# ADDENDUM No. 1

Reference: Generator Upgrade – Larry H. Miller Campus  
Salt Lake Community College  
DFCM Project No. 08073660

Project: Buildings 5-9 Emergency Generator Improvements  
Salt Lake Community College  
Larry H. Miller Campus

DFCM Project No. 08073660

## BUILDING 6 - REVISED ELECTRICAL ROOM LAYOUT (REVISE SHEET E-105)

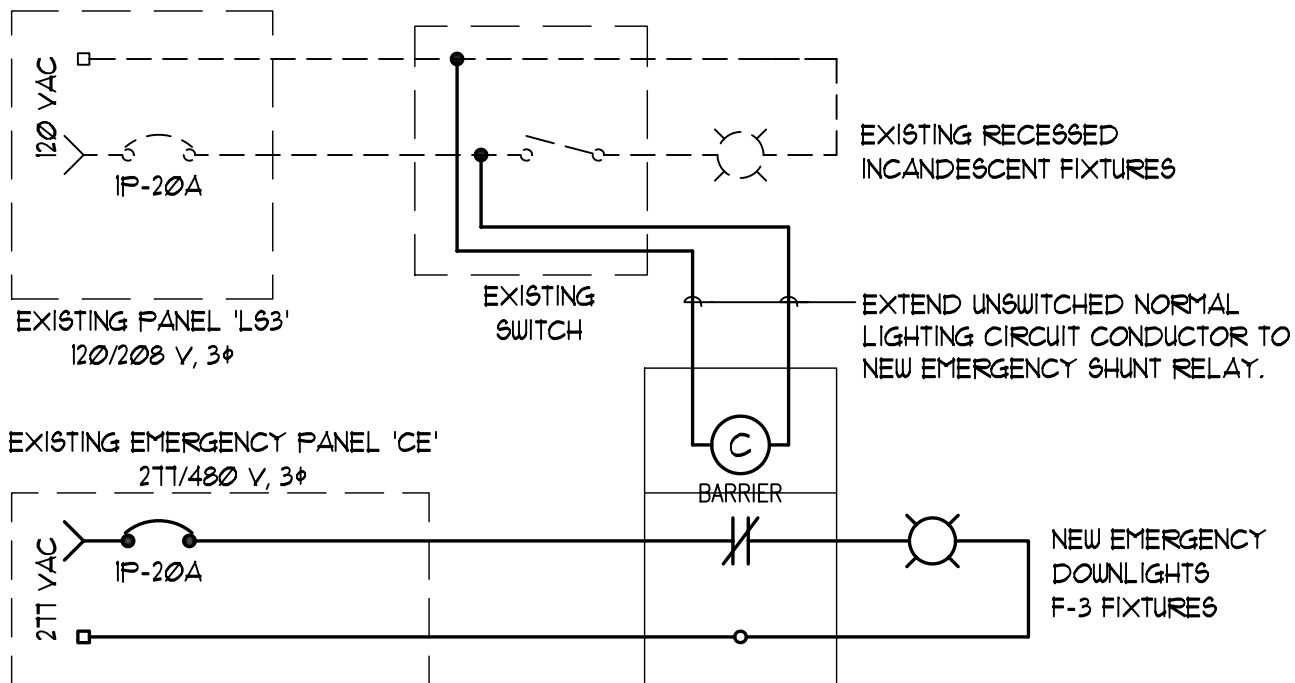
- E. Revise location of new ATS6 in Building 6 Electrical Room as shown attached Supplemental Electrical Drawing SE-2, to coordinate with existing conditions.

- 1 EXTEND 2" CONDUIT STUB-UPS OVERHEAD TO NEW 'AT66A' AND INSTALL NEW FEEDER CONDUCTORS AS SHOWN ON SINGLE LINE DIAGRAM, SHEET E-601.
- 7 PROVIDE UNISTRUT P1001-B-PG, OR EQUAL HOT-DIP GALVANIZED DOUBLE 'C' CHANNEL SUPPORT, VERTICAL FROM FLOOR TO STRUCTURE ABOVE. SECURE TO FLOOR WITH UNISTRUT P2073-A BRACKET AND (4) 3/8" x 3" LAG BOLT WITH LEAD EXPANSION SHIELD. SECURE TO STRUCTURE WITH SUITABLE BEAM CLAMPS. BOTTOM OF STRUCTURE IS APPROXIMATELY 14 FEET ABOVE FINISHED FLOOR.
- 8 PROVIDE UNISTRUT P1000-PG, OR EQUAL HOT-DIP GALVANIZED 'C' CHANNEL SUPPORT, HORIZONTALLY AS REQUIRED TO SUPPORT NEW TRANSFER SWITCH AND CONDUITS.

# BLDG 6 BANQUET ROOMS EMERGENCY LIGHTING CONTROL WIRING DIAGRAM

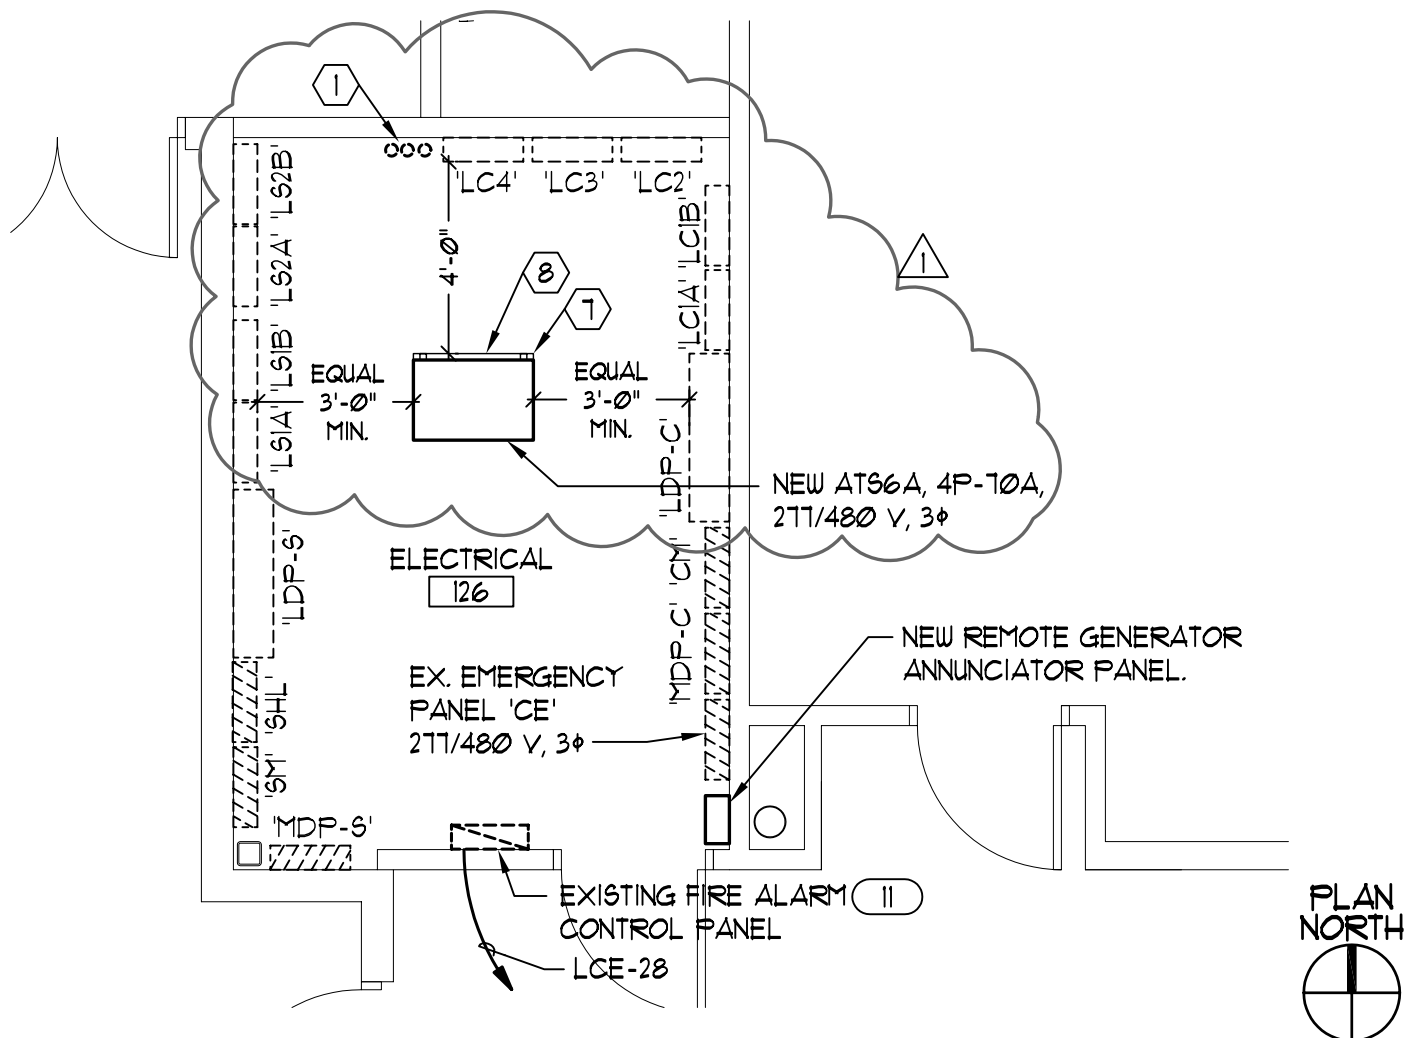
- A. Add Building 6 Banquet Rooms Emergency Lighting Control Diagram as shown on Attached Supplemental Electrical Drawing SE-1.

1. CONTROL DIAGRAM IS TYPICAL FOR EACH OF TWO BANQUET ROOMS IN BUILDING 6.

## GENERATOR CONTROL RISER DIAGRAM SCHEMATIC

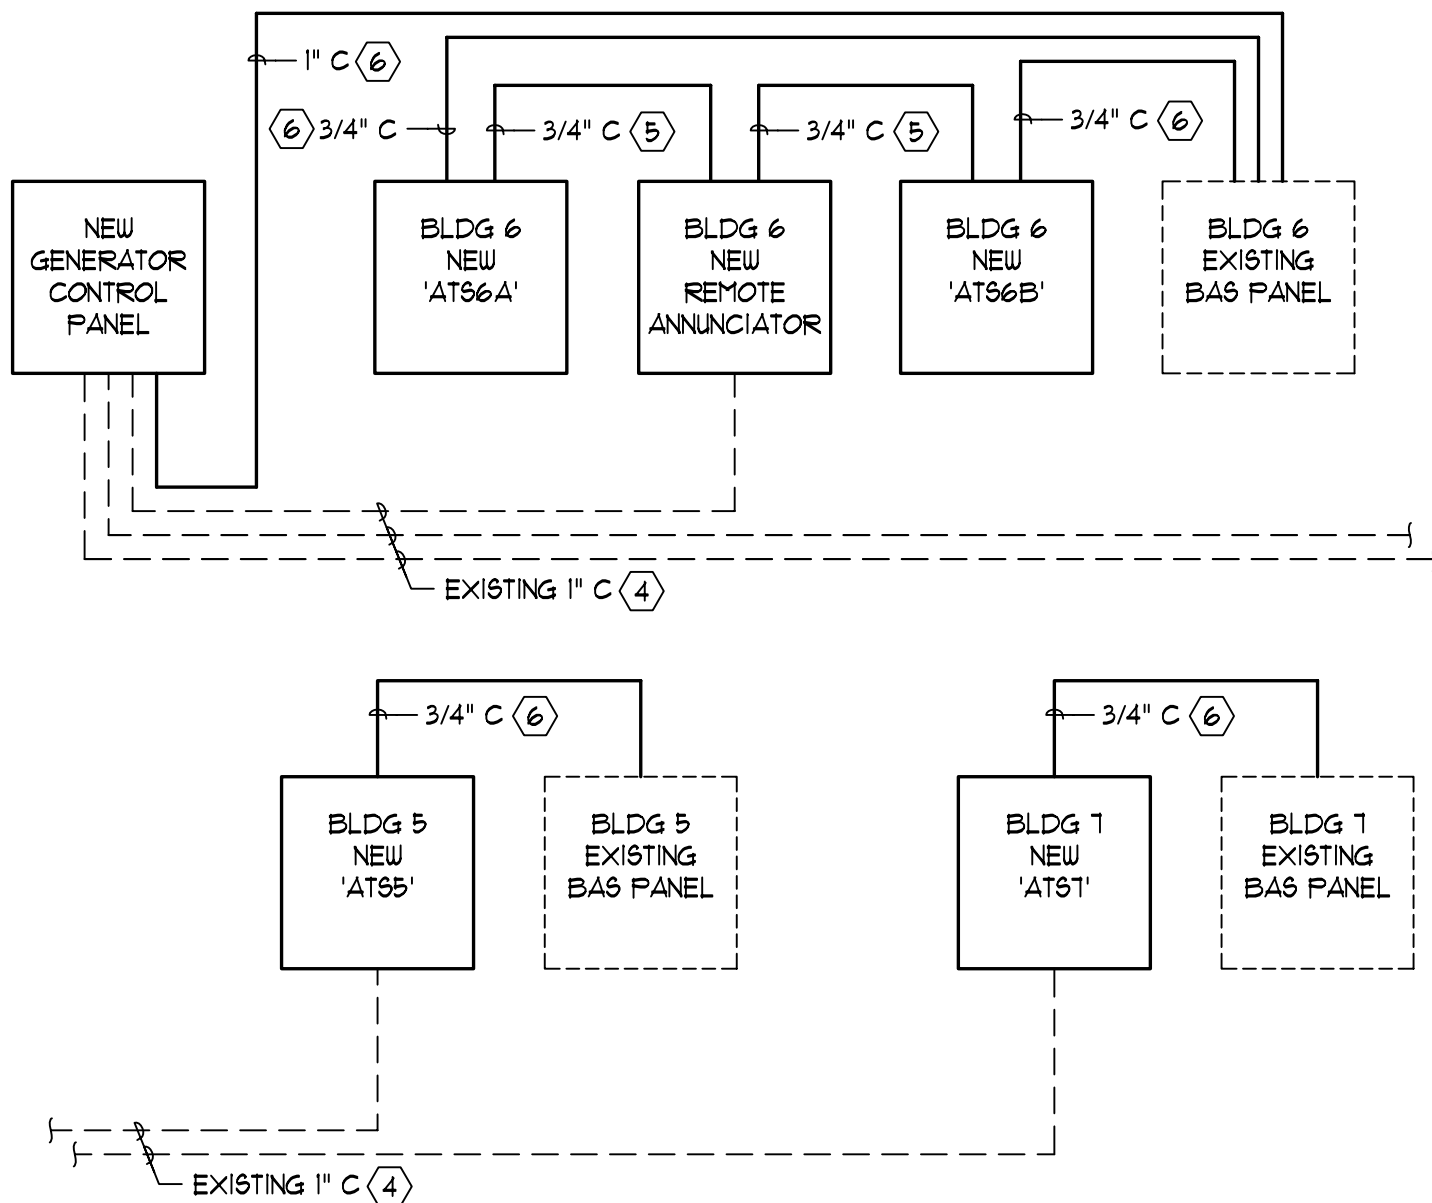
- D. Existing 1" conduit stub-up for Generator Control is located below Existing Panel 'CE', not at New ATS6A location. Extend conduit to Remote Annunciator Panel and provide new conduit from the Remote Annunciator Panel to each new transfer switch for generator control wiring. See Supplemental Electrical Drawing SE-3 for clarification.

- A. Add Generator Control Conduit Riser Diagram as shown on Attached Supplemental Electrical Drawing SE-3.
7. SUBMITTALS FOR PRIOR APPROVAL
- A. Listing herein of the following equipment submitted for prior approval indicates that the brand name and general characteristics are acceptable, but does not relieve the Contractor of the responsibility of providing equipment and accessories as specified in the Contract Documents unless specific mention of the departure was made in the submittal and acknowledged in writing by the Architect and/or Engineer.

- ④ EXTEND EXISTING 1" UNDERGROUND CONDUITS TO NEW GENERATOR AND AUTOMATIC TRANSFER SWITCHES AS INDICATED. PROVIDE NEW CONTROL WIRING IN ACCORDANCE WITH GENERATOR MANUFACTURER'S REQUIREMENTS.
- ⑤ PROVIDE NEW CONDUIT WITH NEW CONTROL WIRING IN ACCORDANCE WITH GENERATOR MANUFACTURER'S REQUIREMENTS.
- ⑥ PROVIDE NEW CONDUIT TO EXISTING BUILDING AUTOMATION SYSTEM (BAS) CONTROL PANEL FOR OFF SITE MONITORING OF GENERATOR AND AUTOMATIC TRANSFER SWITCHES.
